UNITED STATES PATENT AND TRADEMARK OFFICE

Office Action Summary	Application No. 10/534,690	Applicant(s) OCHI ET AL.	
	Examiner DNYANESH KASTURE	Art Unit 3746

DETAILED ACTION

5. Claims 3 - 5 and 8 - 14 are rejected under 35 U.S.C. 103(a) as being unpatentable over Horiuchi et al (PCT Publication WO01/21959) in view of Chandler et al (US Patent 3,593,103 A) as extrinsically evidenced by Applicant's disclosure of Prior Art (hereafter referred to as "Prior") and further in view of Fujita (US Patent 3,440,508 A)

Fig. 1

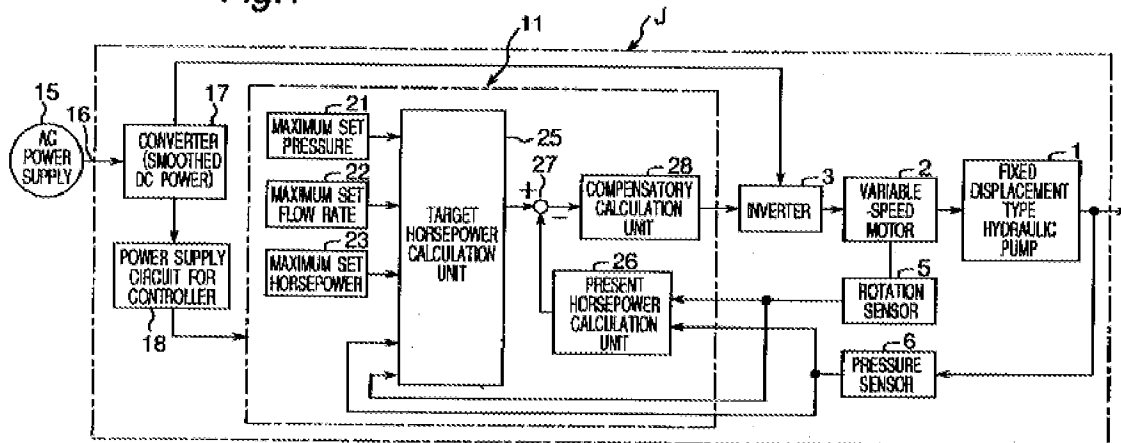
6. In Re claim 3 and 8, with reference to Figure 1 depicted above, Horiuchi et al discloses a pump driving method comprising:

- driving a motor (2) using a controller (11) which executes commands (values)

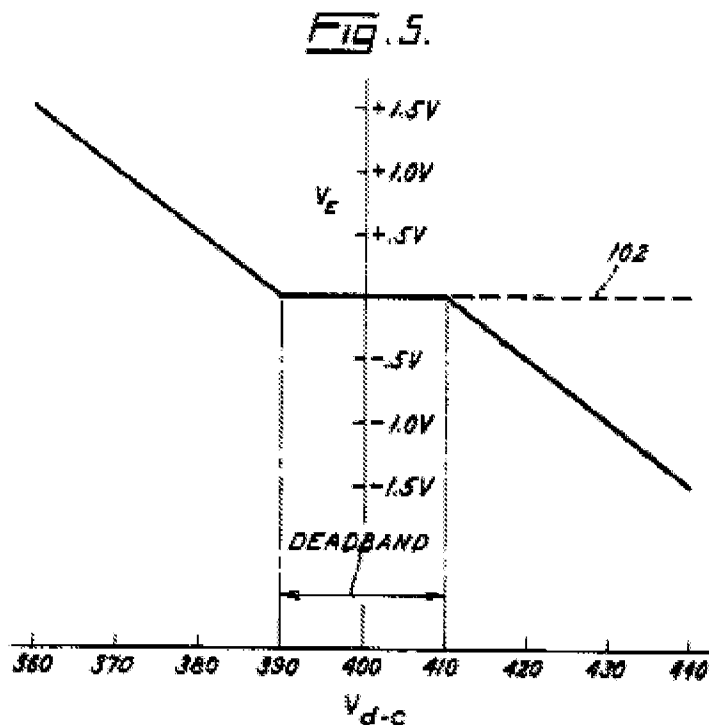
- carrying out feedback control of the discharge pressure using the signal from the pressure sensor (6) (as described in line 3, Page 4, Paragraph [0021])
 - driving a pump (1) using motor (2) (as described in line 14, Page 4, Paragraph [0021])
 - an apparatus (11), (21), (22), (23), (25), (27), (28) that is capable of making changes to the control algorithm if necessary
7. However, Horiuchi et al does not disclose changing the command value in correspondence with a changing amount of a detected power source voltage.

8. Nevertheless, with reference to Figure 5 depicted above, Chandler et al discloses a control circuit (Figure 3) for an inverter (40) that drives the motor comprising:
- coupling line (88) to the DC bus from DC Rectifier (20)

- a voltage sensing circuit (90) that generates a representative control signal V_E that has a command value which is proportional to the deviation of the bus voltage from a predetermined magnitude range or deadband (Column 4, Lines 58-62)
- Referring to Figure 5, in a condition when the detected power source voltage increases, the magnitude (command value) of the control signal V_E also increases

Blow up of Figure 6B of Chandler et al

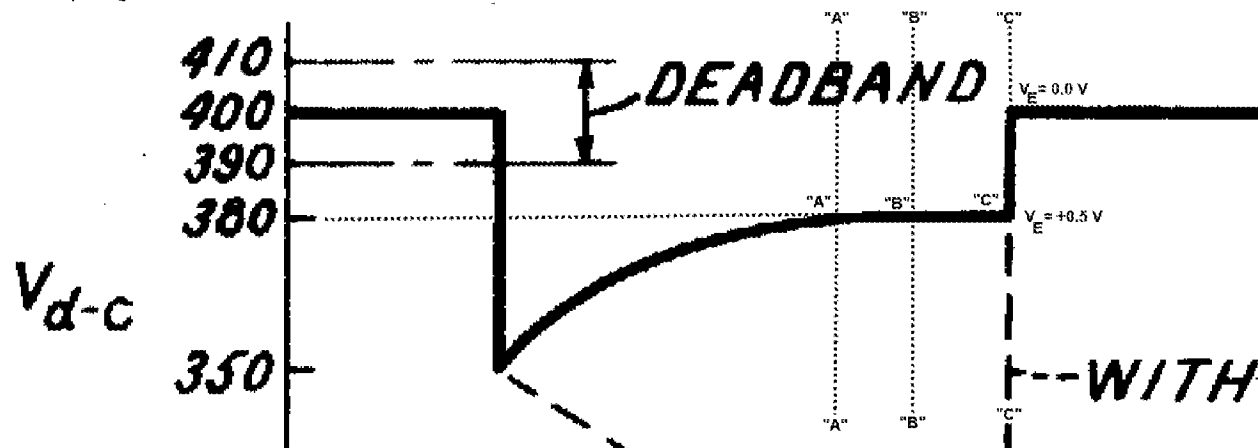
14. With reference to applicant's arguments, as annotated in the Blow-up of Figure 6B depicted above, once the power outage occurs, V_{d-c} stabilizes at 380 Volts at point "A" in time and stays at that value for the duration of the power outage up until point "C". From Figure 5, the corresponding value of V_E is +0.5 Volts (for $V_{d-c} = 380$ Volts). Therefore the value of V_E stabilizes at +0.5 volts at point "A". Point "A" marks the time when the command value is "last changed". Moving now to point "B", the last changed command value of +0.5 volts is "maintained" even though the DC voltage $V_{d-c} = 380$

volts is "judged not to be the ideal value". Any point in time between points "A" and "B" is at a condition that reads on the claim limitation "maintaining the last changed command value upon judging that the detected DC voltage is not the ideal DC value of the alternating current power source". At point "C" when power is restored, the "detected DC voltage value" now becomes the "ideal DC voltage value" of 400 Volts, at the same time "changing the command value" from +0.5 volts to 0.0 volts. The transition that occurs at point "C" therefore reads on the claim limitation "changing the command value for the detected DC voltage upon judging that the detected DC voltage is the ideal DC voltage value of the alternate current power voltage".

Blow up of Figure 8B of Chandler et al

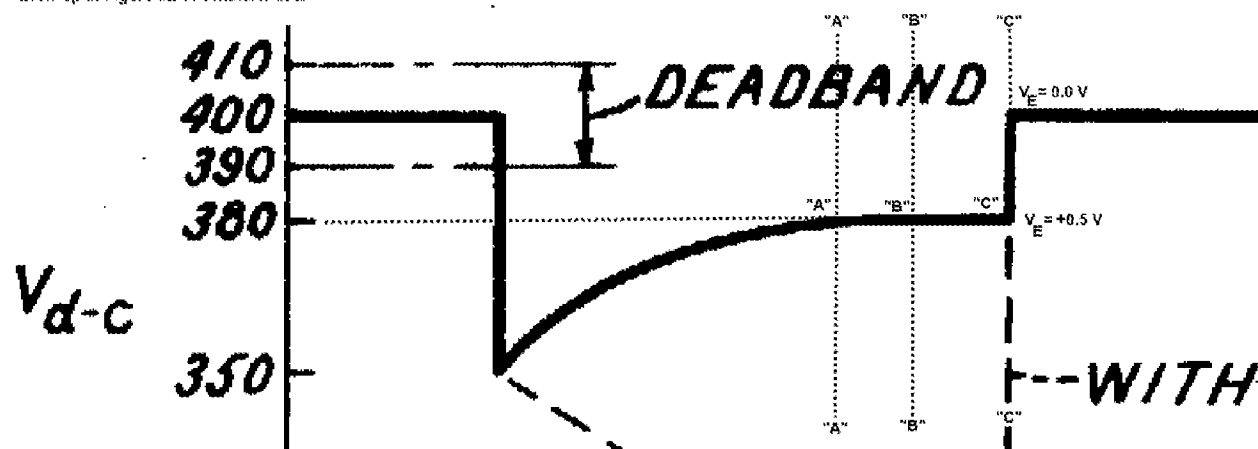
17. In Re claim 12 and 14, Figure 6 of Chandler et al depicts that the "soft return" time is greater than the power loss time ($T_2 - T_1$). In this case, the return voltage is not higher than its normal value within the deadband, therefore the increase in speed is less

than a value that would correspond to excessive speed (second pre-determined value).

Also, during the power dip, the speed is less than normal (first predetermined value).

Note also that phrase "soft return" implies that the voltage has returned to normal and is therefore at ideal value.

20. As annotated in the Blow-up of Figure 6B depicted above, once the power outage occurs, V_{d-c} stabilizes at 380 Volts at point "A" in time and stays at that value for the duration of the power outage up until point "C". From Figure 5, the corresponding value of V_E is +0.5 Volts (for $V_{d-c} = 380$ Volts). Therefore the value of V_E stabilizes at +0.5 volts at point "A". Point "A" marks the time when the command value is "last changed". Moving now to point "B", the last changed command value of +0.5 volts is "maintained" even though the DC voltage $V_{d-c} = 380$ volts is "judged not to be the ideal value". Any point in time between points "A" and "B" is at a condition that reads on the claim limitation "maintaining the last changed command value upon judging that the detected DC voltage is not the ideal DC value of the alternating current power source". At point "C" when power is restored, the "detected DC voltage value" now becomes the "ideal DC voltage value" of 400 Volts, at the same time "changing the command value" from +0.5 volts to 0.0 volts. The transition that occurs at point "C" therefore reads on the claim limitation "changing the command value for the detected DC voltage upon judging that the detected DC voltage is the ideal DC voltage value of the alternate current power voltage".
